DRURY METROPOLITAN CENTRE PRECINCT - CONDITIONS

Purple text = amendments proposed by Kiwi Property to address 'Memorandum s67 - Further Information' from Auckland Council

Blue text = amendments proposed by Kiwi Property as part of s67 RFI response dated 19 September 2025

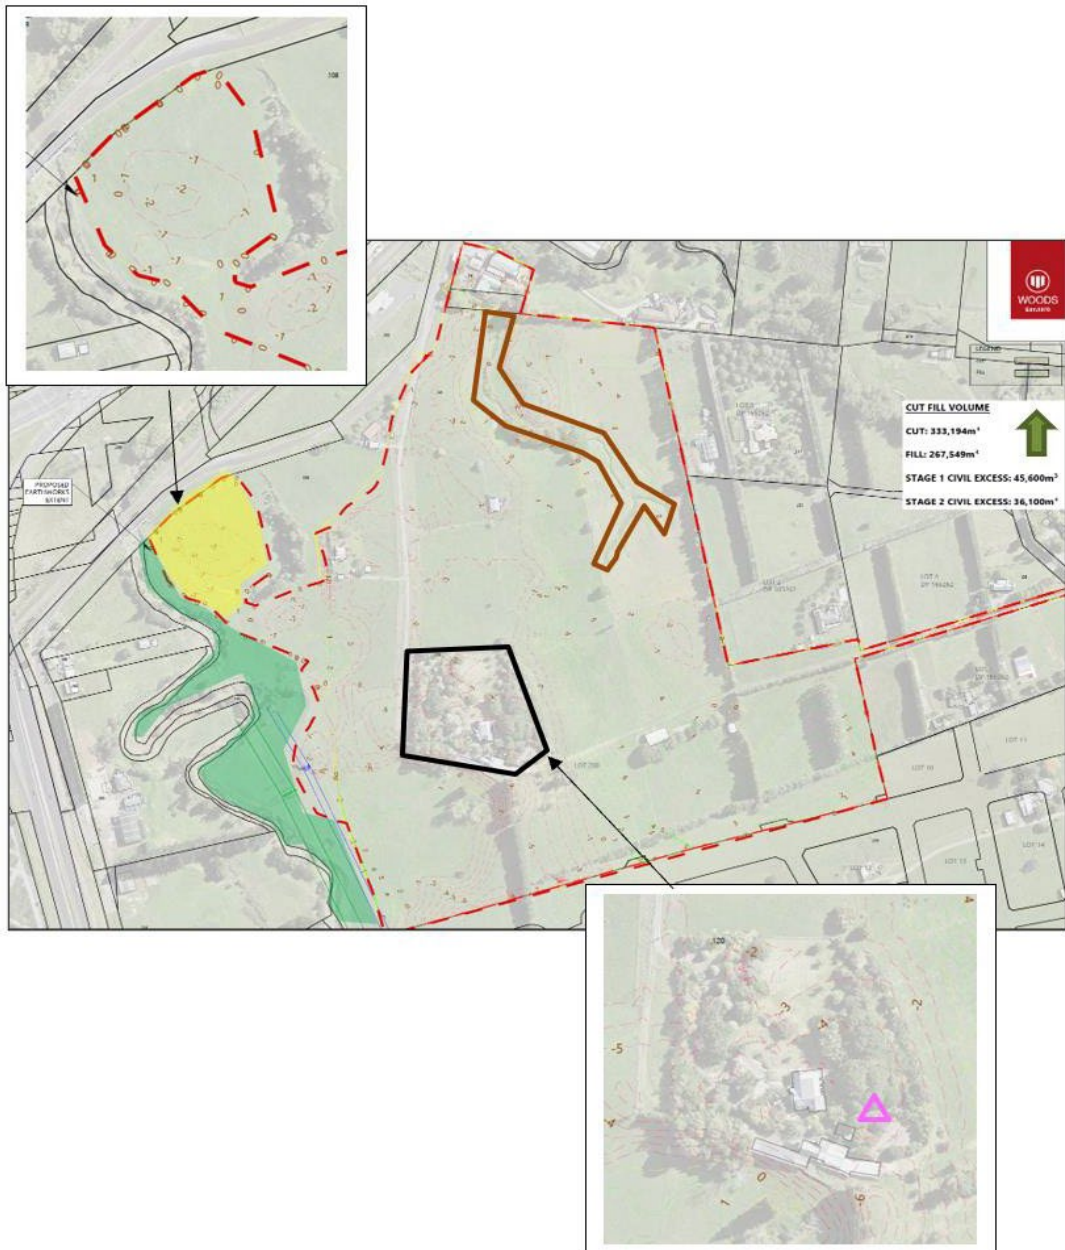
77. The consent holder must ensure the boardwalk over Stream A as indicatively shown on the Landscape Design Report prepared by Boffa Miskell and dated March 2025 referenced in Condition 1 is constructed to comply with Standard E3.6.1.16 of the AUP and must achieve the following:
- (a) Piles must not be located in, on or under the bed of the stream;
 - (b) The total length of the structure does not exceed 30m;
 - (c) During construction bed disturbance upstream or downstream of the structure must not exceed 10m either side, excluding the length of the structure; and
 - (d) Any required erosion or scour management works must not exceed 5m in

length, either side of the structure.
